Access Compliance Report Public Rights-of-Way (Curb Ramps)

Intersection ID: 9919 Main Street: N_CHURCH_ST Cross Street: W_28TH_ST Location: W

ADA ID: 012F1F6A16CF Ramp Type: Perp Initial Pass/Fail: Fail Overall Compliance: No Severity Score: 61.25

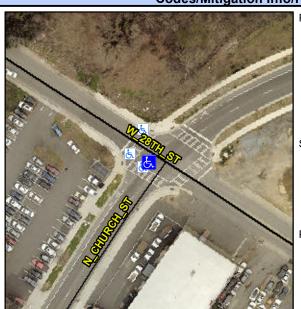
Not Found, R304.5.1, R304.2.2, R304.5.3

R304.5.3

Remove & Replace Entire Ramp.
